Addendum #1 for
St. Joseph University Catholic Parish
Terre Haute, IN
Parish Hall
September 15, 2026

entheos ARCHITECTS
802 Lord Street, Ste. 200
Indianapolis, IN 46202
Ph (317) 951-9590

CHANGES TO THE DRAWINGS

5 Hand Rail Details
Scale: 1-1/2" = 1'-0"

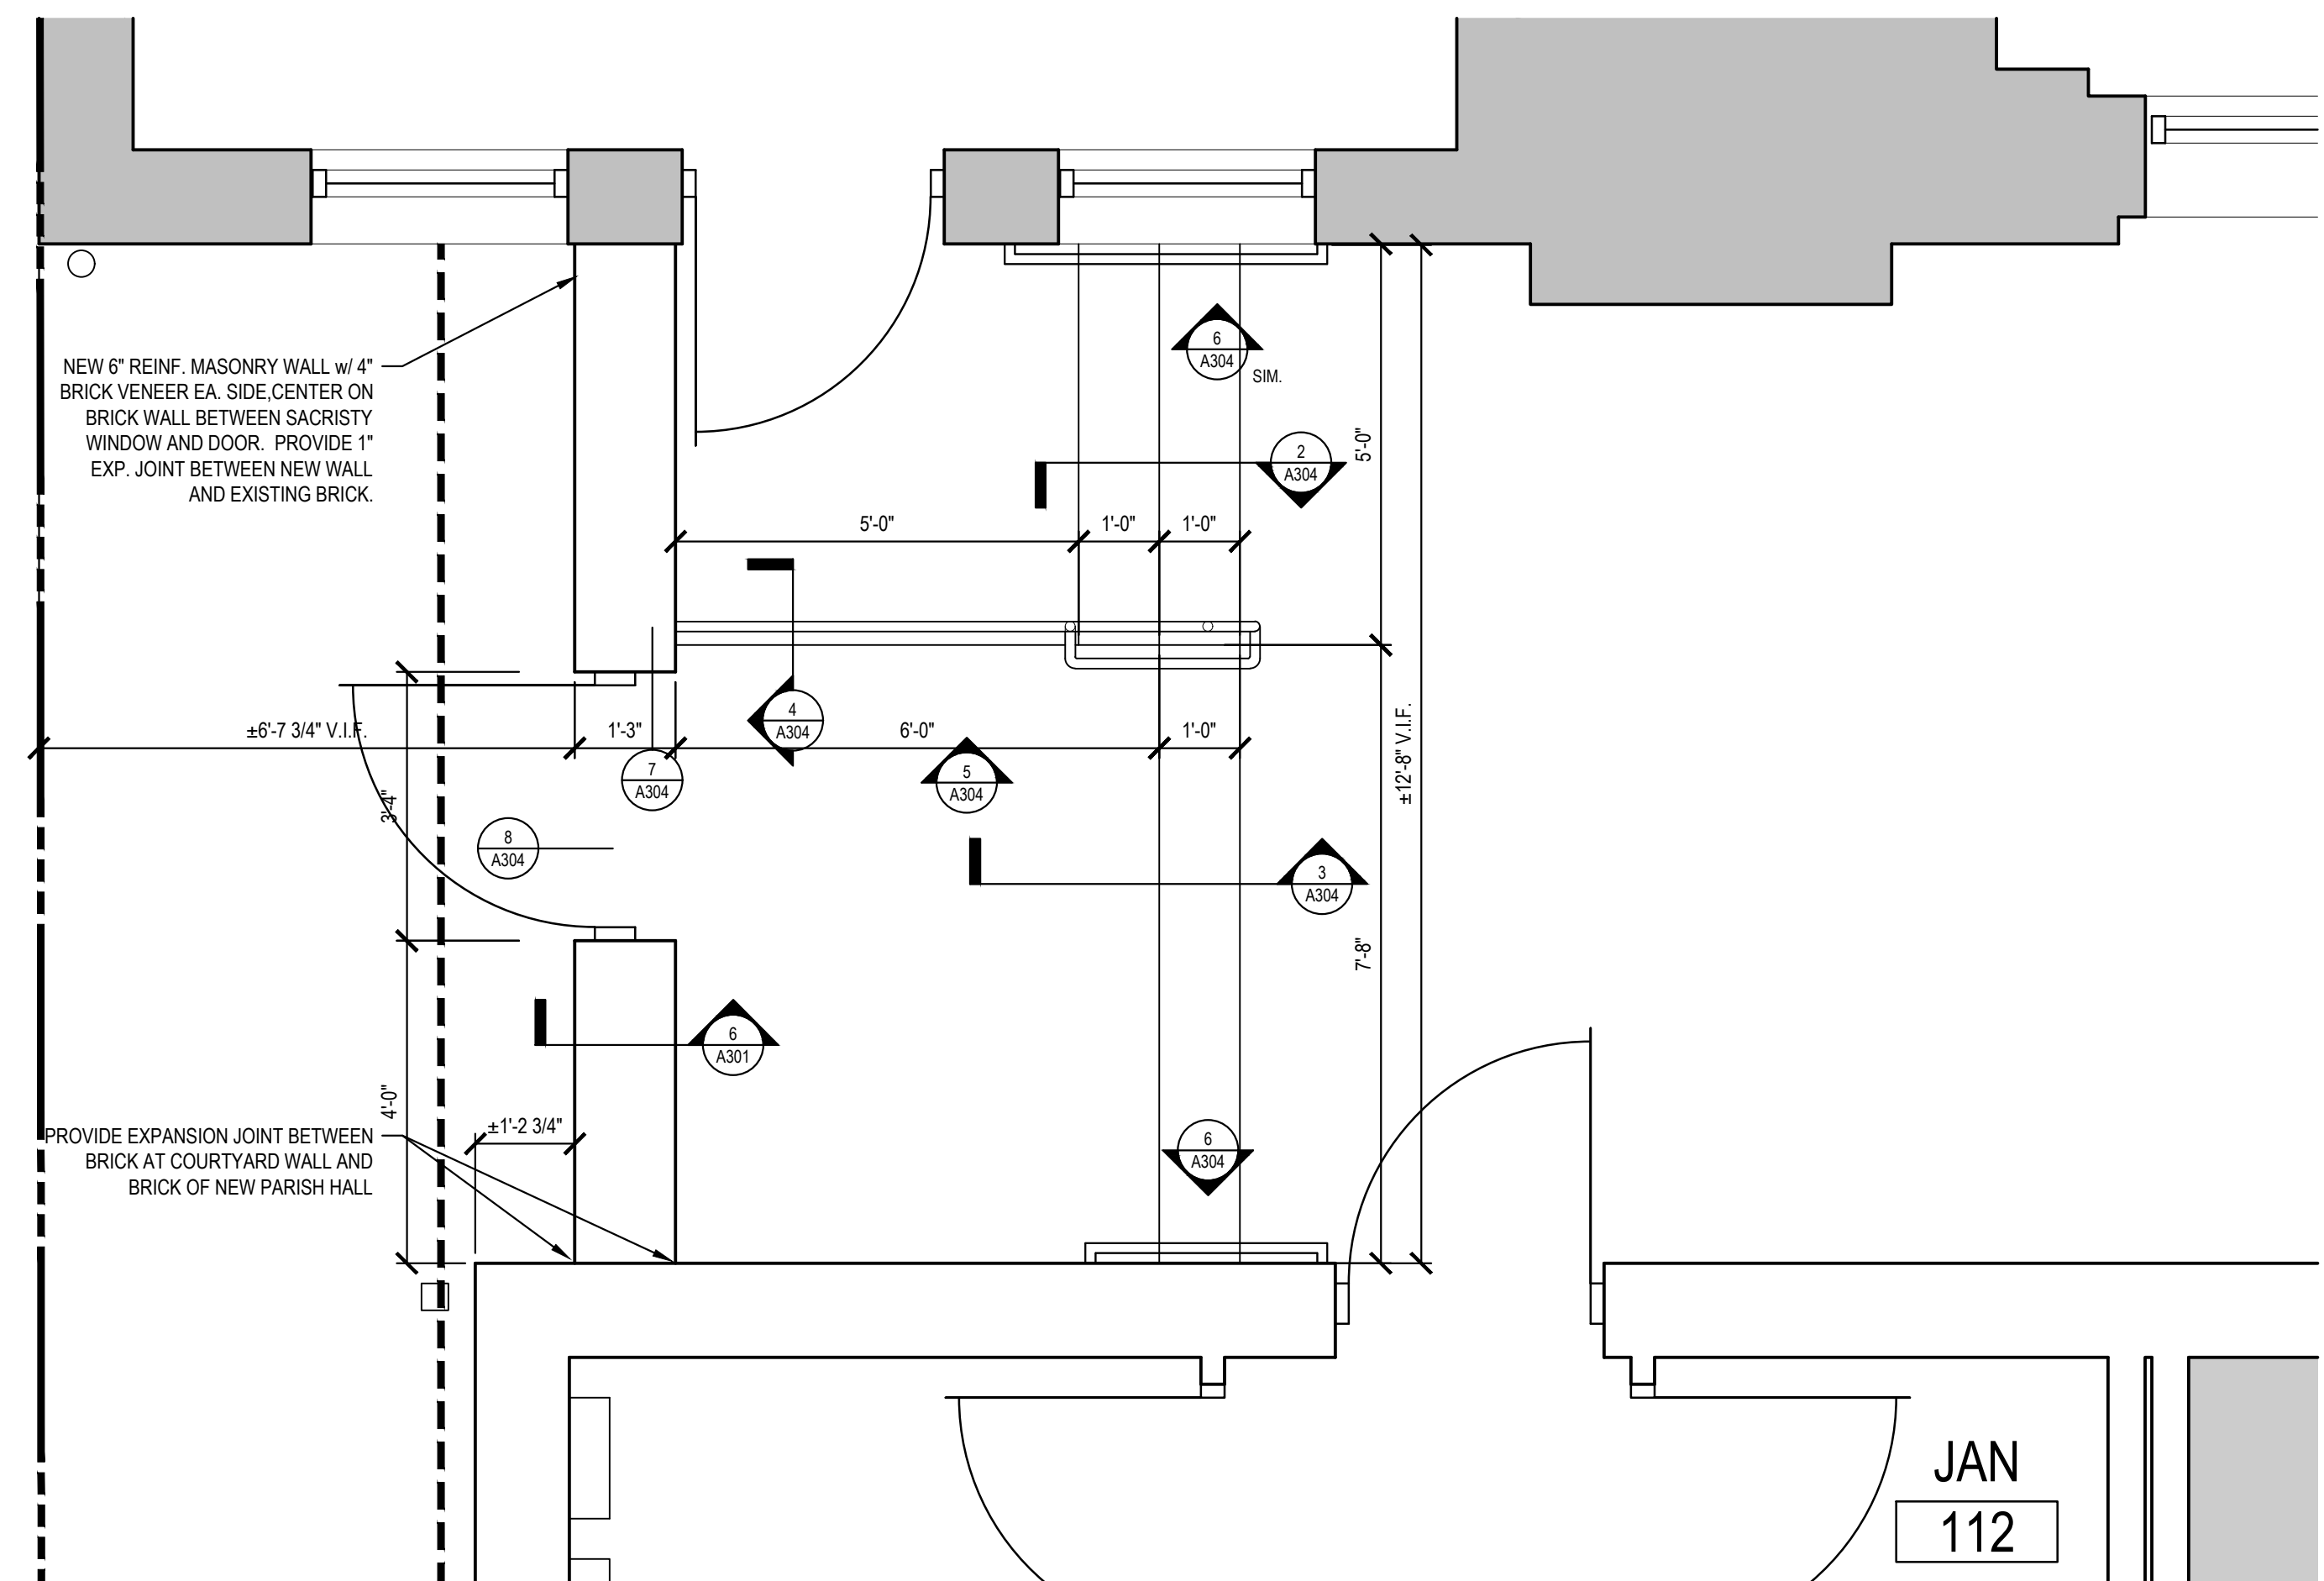
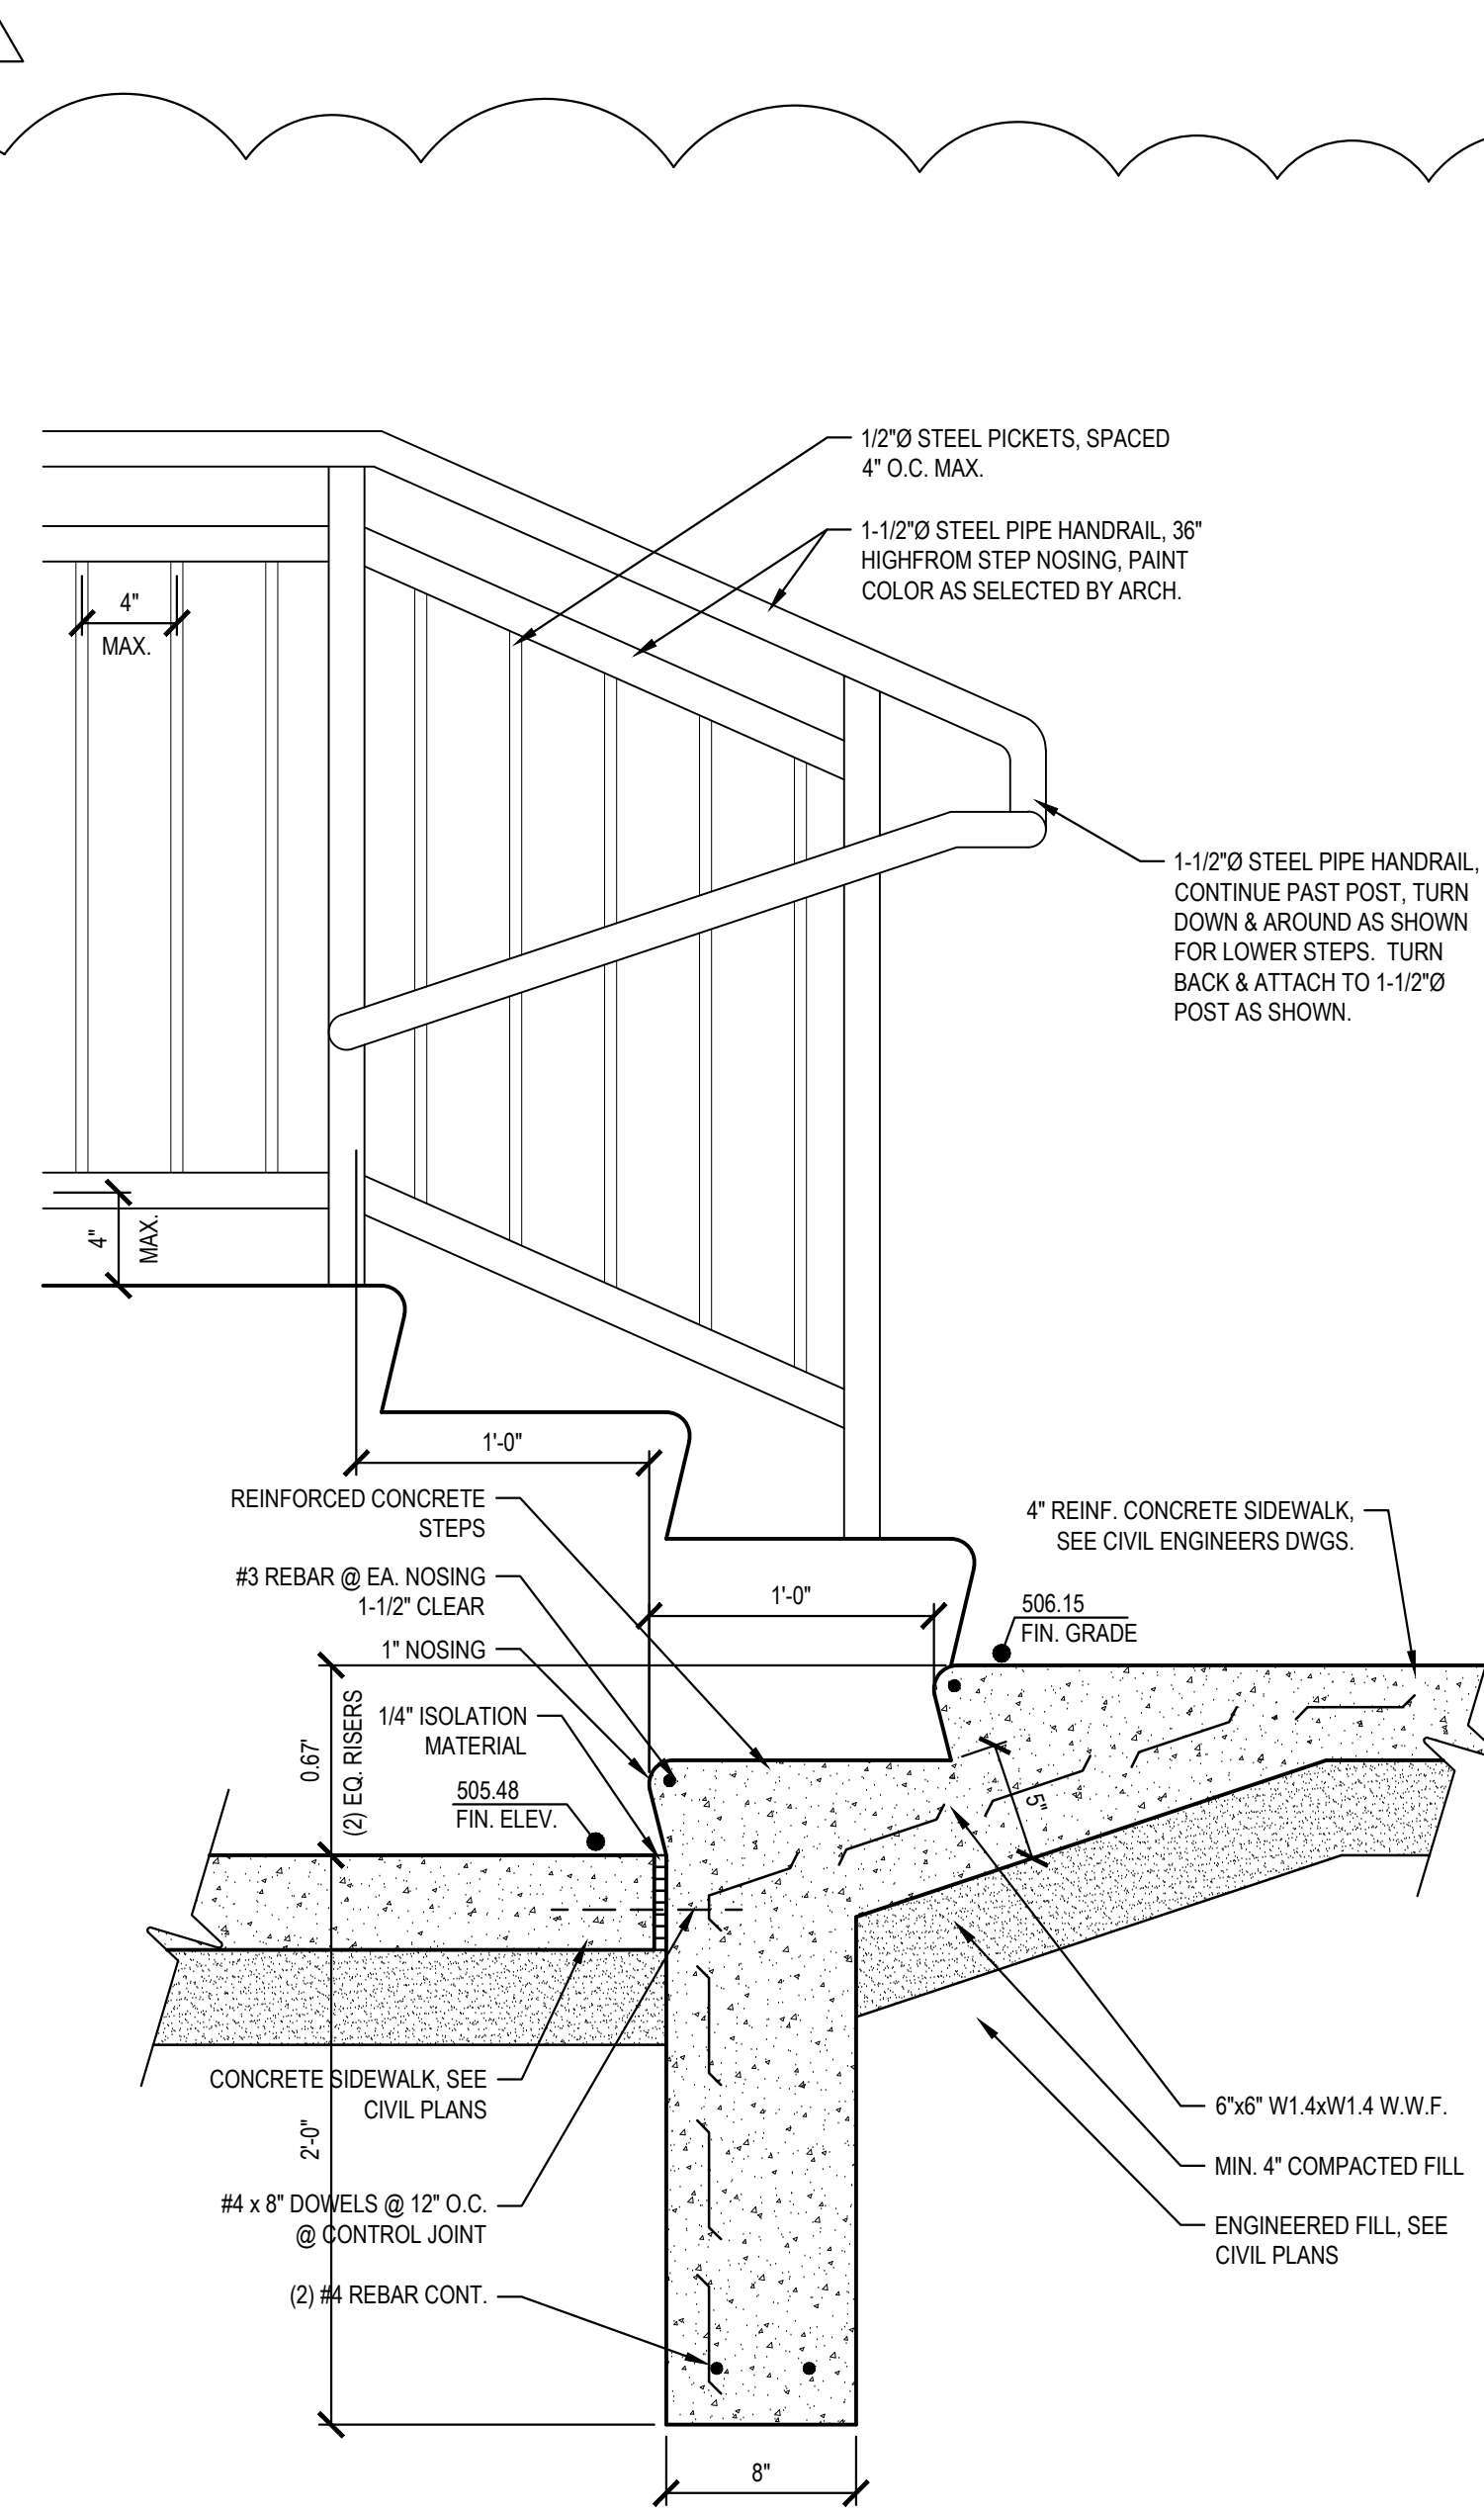
2. Revise Step and Railing Details. Replace sheet in entirety.
